Llanmaes Flood Alleviation
Scheme Flood
Consequence Assessment
Addendum Technical Note

18 February 2022

Vale of Glamorgan Council

Figure 2-1: Frampton Ponds Initial Water Levels

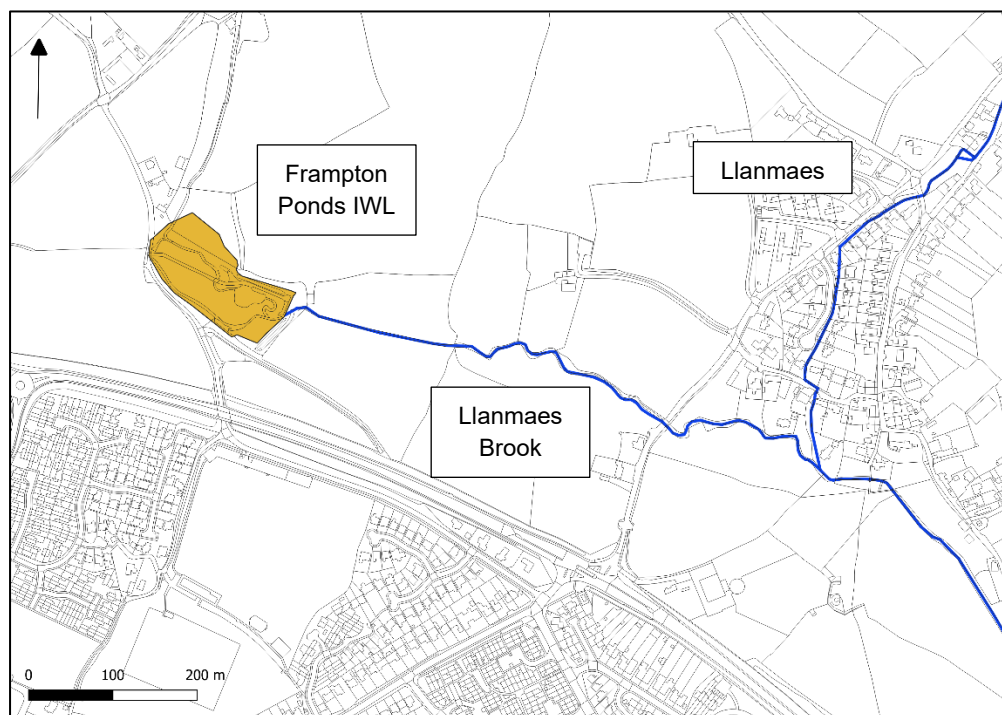
To assess the impact of antecedent catchment conditions it was agreed with NRW on the 19/01/22 (Appendix A1) that a sensitivity simulation would be undertaken applying a starting capacity of 50% and 100% to the flood storage area at Frampton Ponds (approximate NGR 297274, 169656).

A GIS analysis of the volume stored within Frampton Ponds was undertaken using the modelled spillway elevation (55.65m AOD) as the maximum capacity of the flood storage area. This provided a flood storage of approximately 10,000m³ at 100% capacity. Initial water levels were set to 55.65m AOD (100% capacity) and 55.10m AOD (50% capacity) at the beginning of the design event. Figure 2-1 shows the location of the initial water levels applied at Frampton Ponds for the sensitivity simulation.

Figure 3-2: Maximum Depth Difference Plot, Boverton, 1% + 30%CC, Updated Proposed Option vs NRW Reviewed Proposed Option

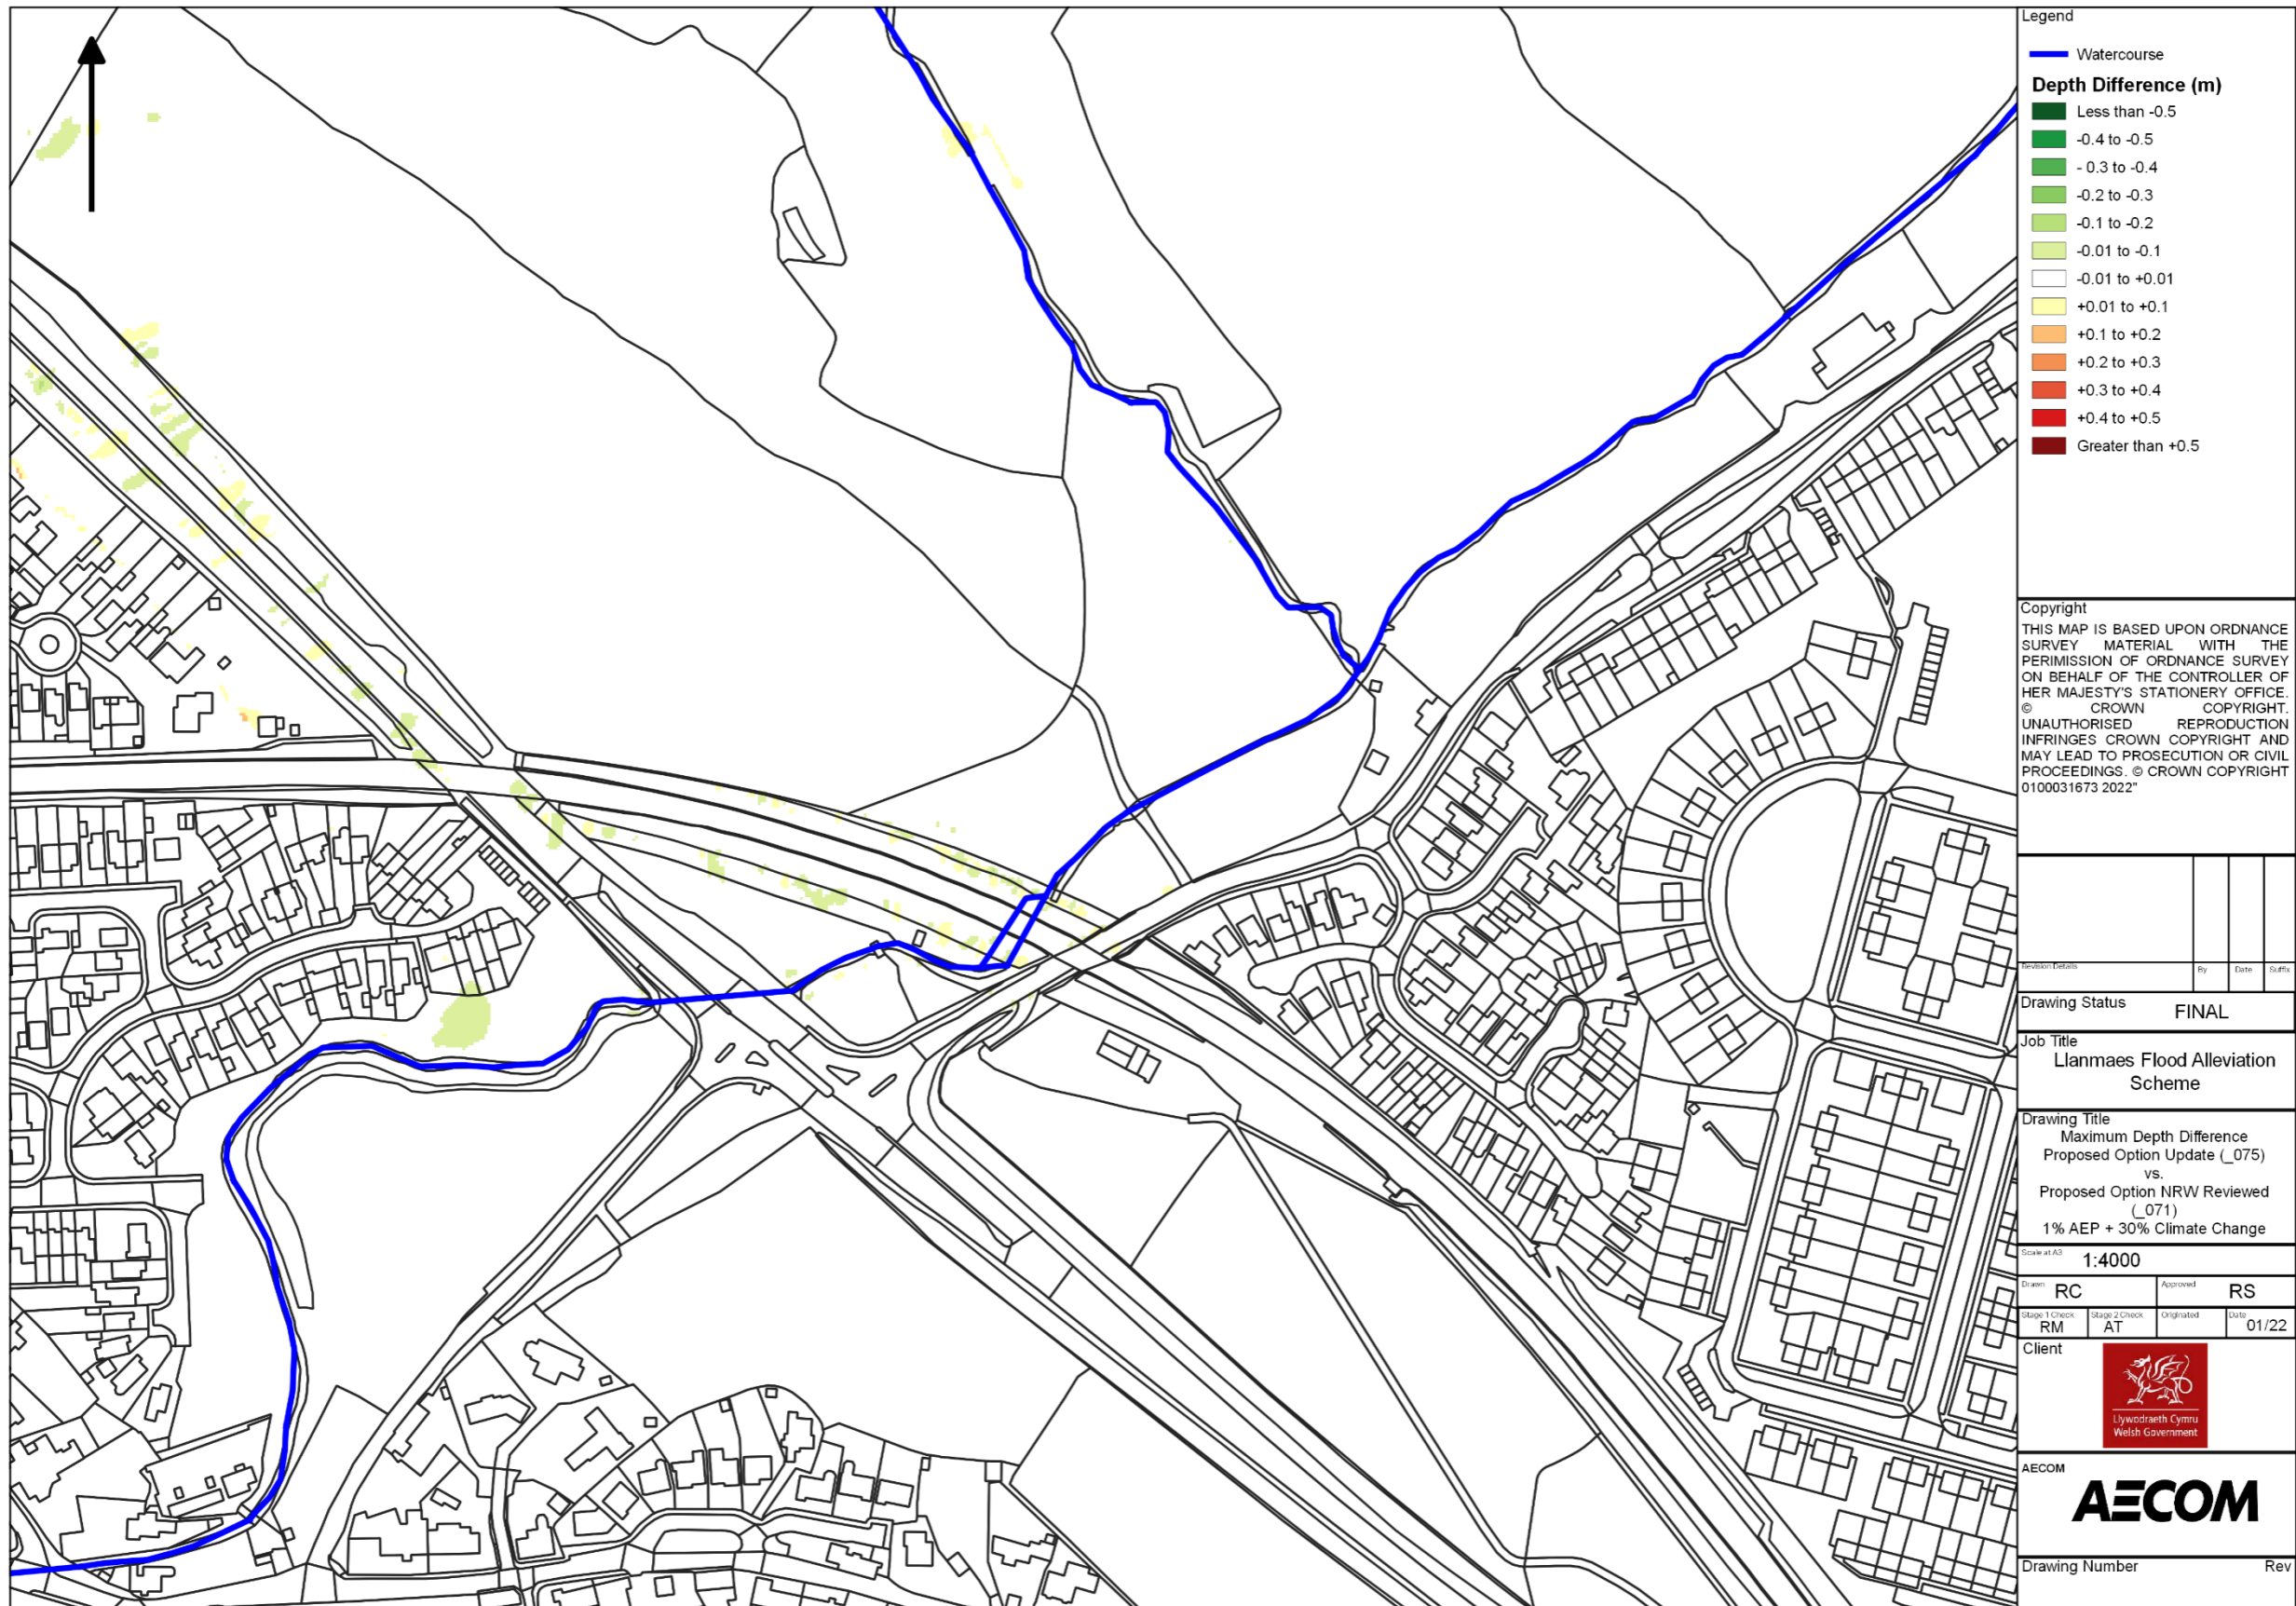
Figure 3-1 and Figure 3-2 show the 1% AEP + 30% Climate Change event maximum flood depth difference plot comparing the updated Proposed Option model results to those reviewed by NRW at Llanmaes and Boverton respectively. Within Llanmaes (Figure 3-1) there are minor reductions in maximum flood depths within the proposed ditches of between -0.01m to -0.10m due to the change in Manning's roughness values and also within Llanmaes Village Green where there have been alterations to the 1D cross section profiles. At Boverton (Figure 3-2) there are minor changes to the maximum flood depths around the railway line due to the reduction in the 2d_bc layer but results are materially the same.

It can be concluded from these results that the Baseline and Proposed Option hydraulic modelling results have not materially changed from those presented within the FCA as a consequence of the model updates described in this report. Therefore the conclusions and outcomes presented within the FCA remain valid.

Figure 3-3: Boverton Brook Sensitivity Flow Comparison Downstream of Boverton Brook Railway Culvert ,1.33% AEP, (Node Bov_042b)

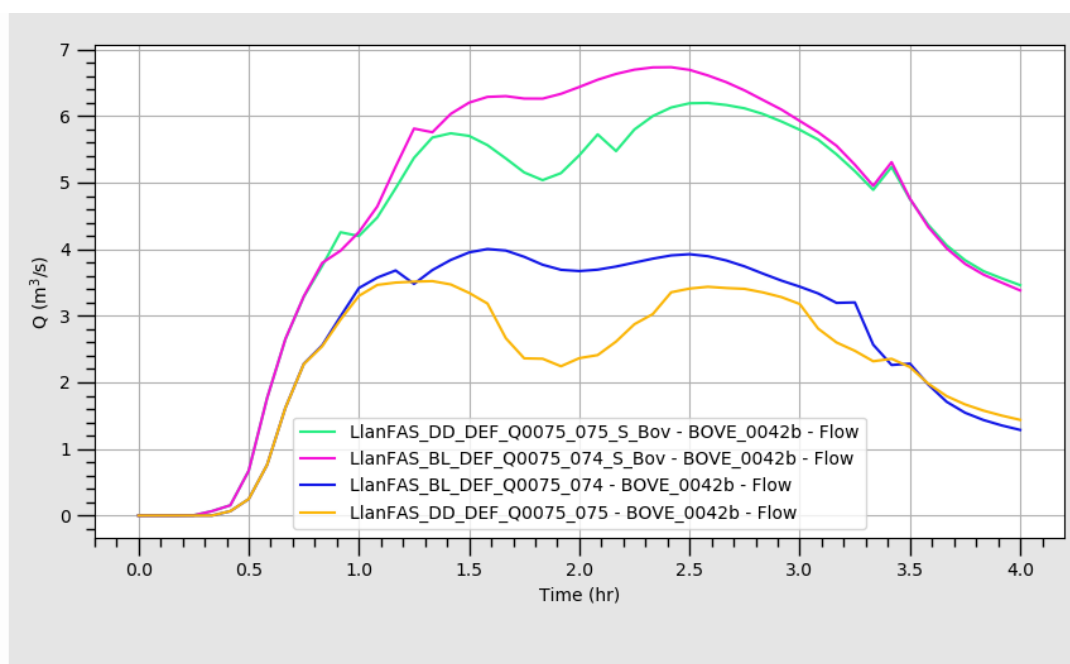
Figure 3-3 shows a comparison of the Baseline and Proposed Option flow hydrographs downstream of the Boverton Brook Railway Culvert and Figure 3-4 shows the maximum flood depths difference map between the Baseline and Proposed Option. Figure 3-3 shows that the peak flow is reduced from 6.7m³/s (pink) to 6.2m³/s (green) in the Proposed Option leading to an overall reduction in maximum flood depths of -0.01m to -0.10m at the Boverton Brook Culvert (Figure 3-4). This demonstrates that there is no detrimental impact downstream of the proposed scheme and remains consistent with the conclusions of the results presented within the FCA.

Figure 3-5: Maximum Depth Difference – Frampton Ponds Sensitivity, 50% Capacity, 1.33% AEP

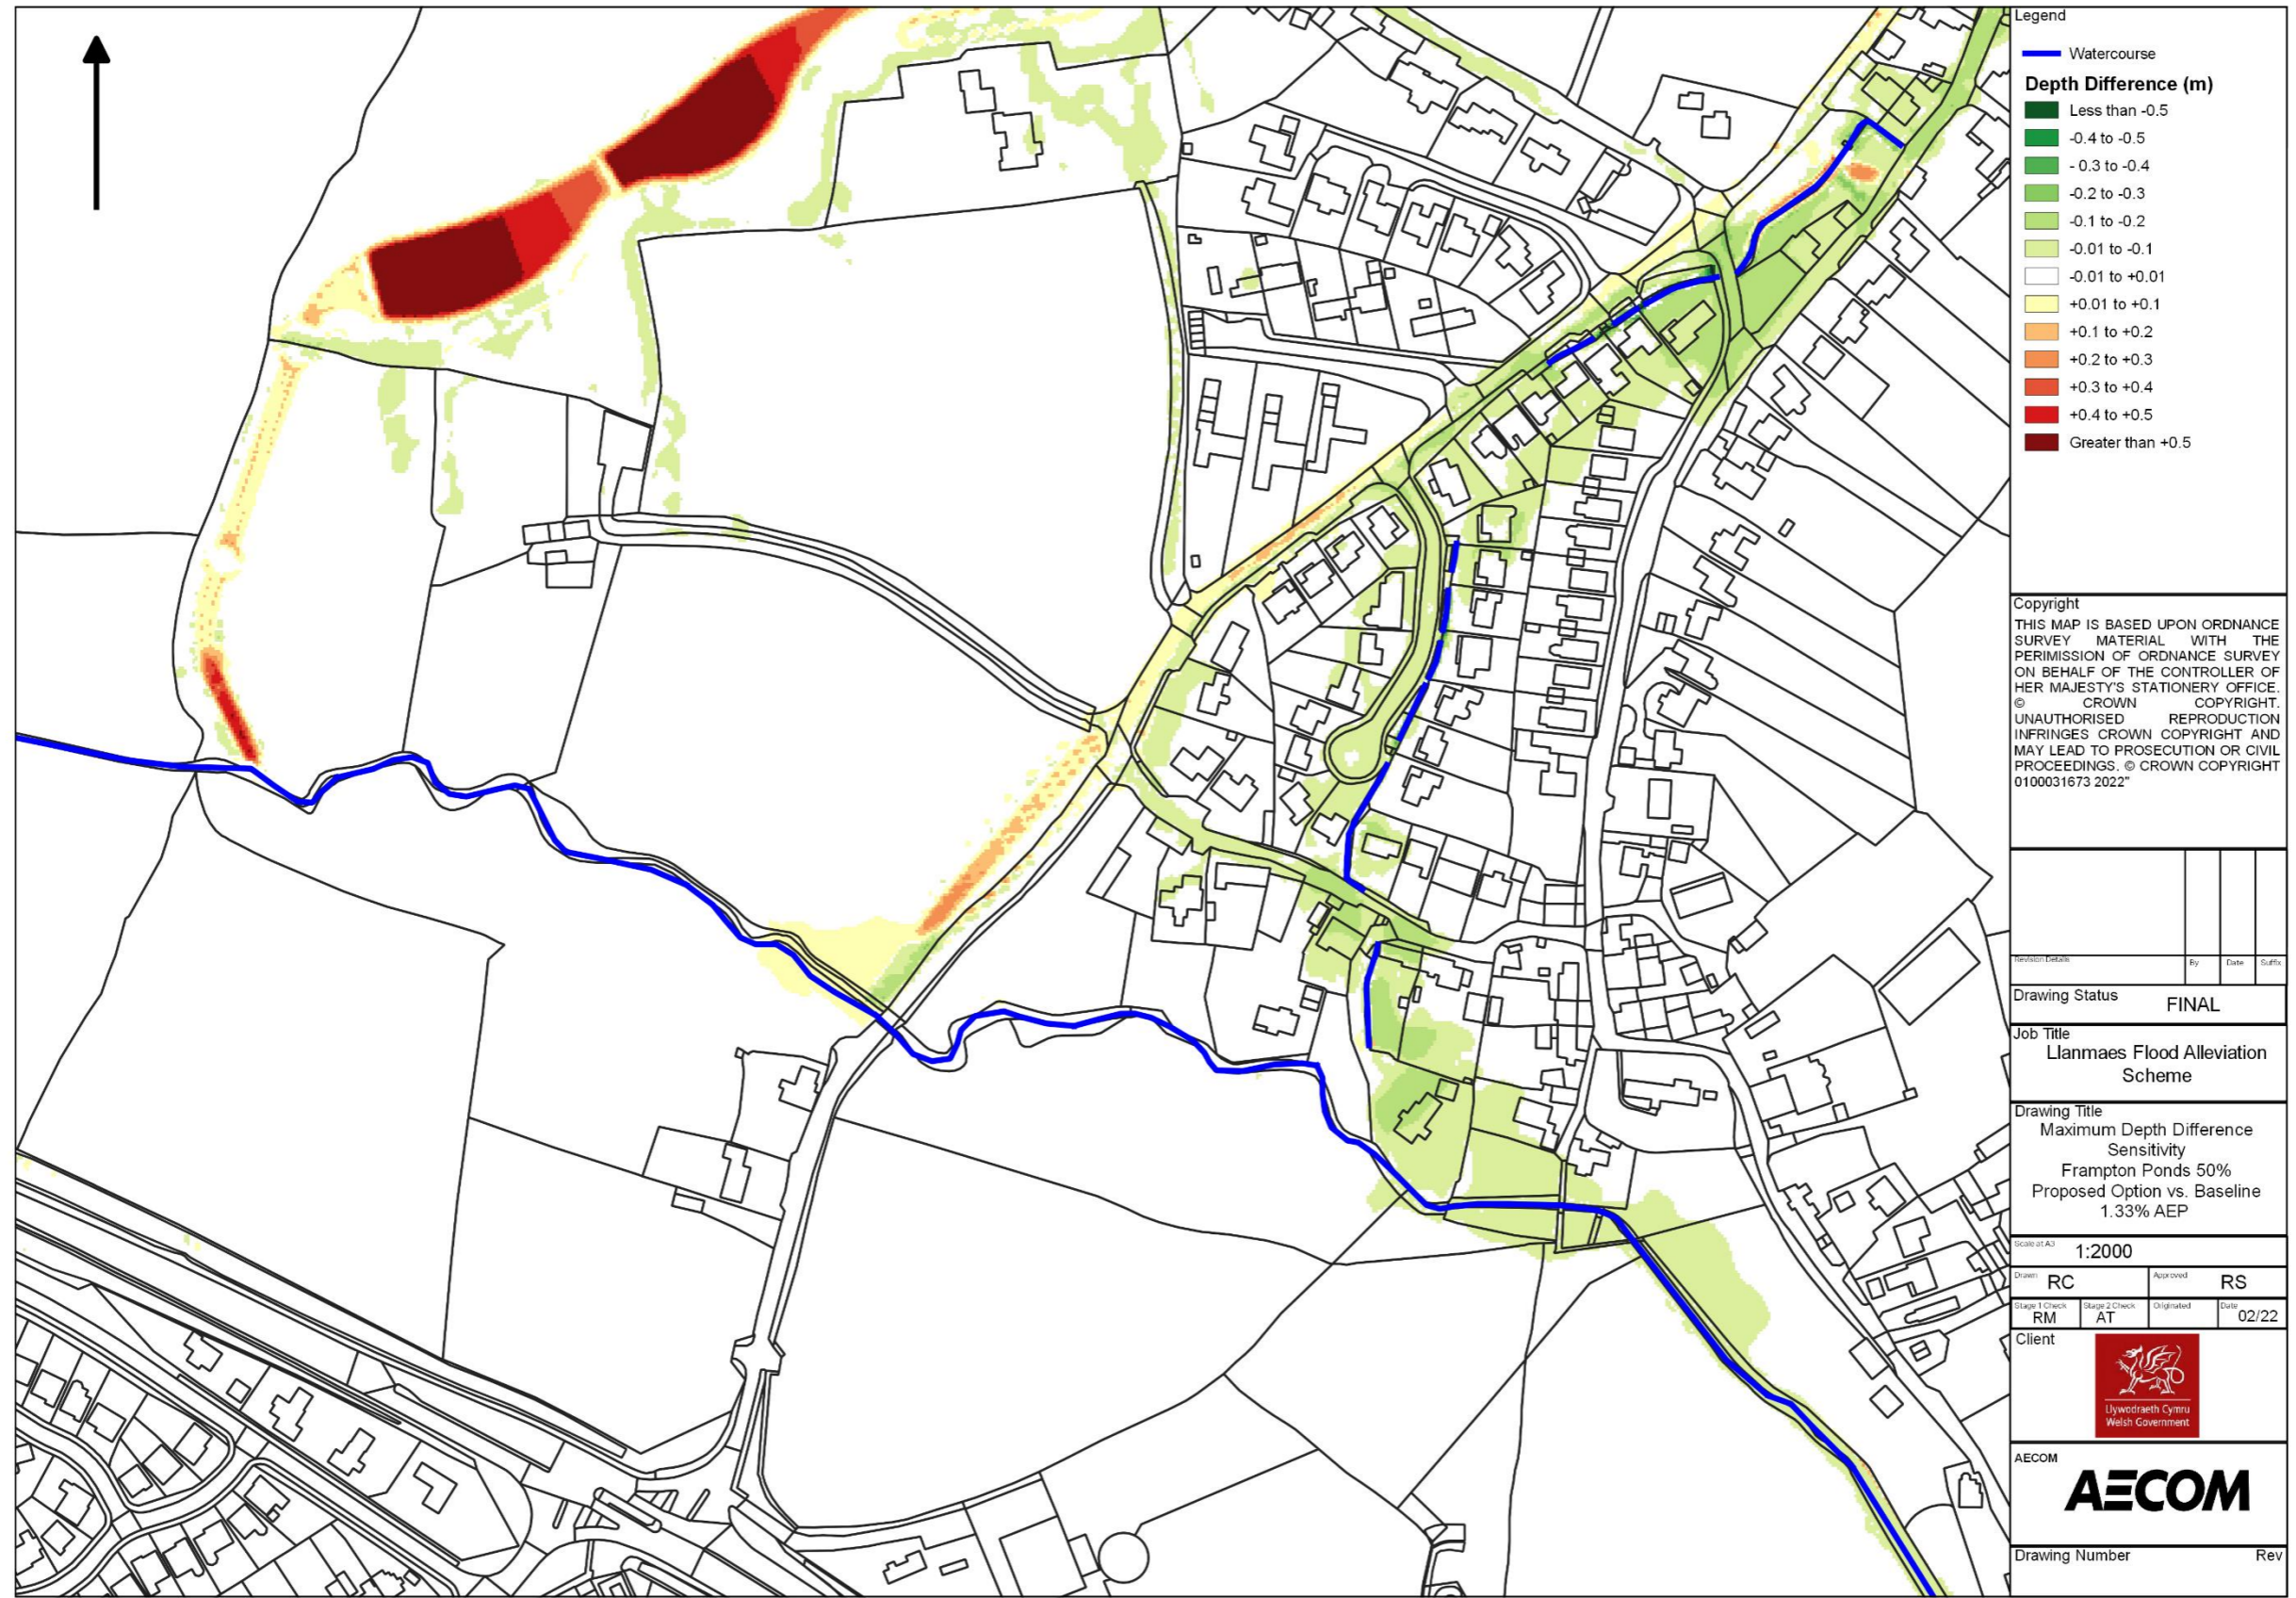
The maximum depth difference plot for Llanames, comparing the Baseline and Proposed Option for the 50% and 100% capacity sensitivity simulations, are shown in Figure 3-5 and Figure 3-6 respectively. There remains an overall reduction in maximum flood depths through Llanmaes with the areas of increased maximum flood depths on Llanames Brook remaining consistent with the results in the design event (Appendix F5). This demonstrates that the proposed scheme functions well under different antecedent conditions and the conclusions of the FCA are still valid.
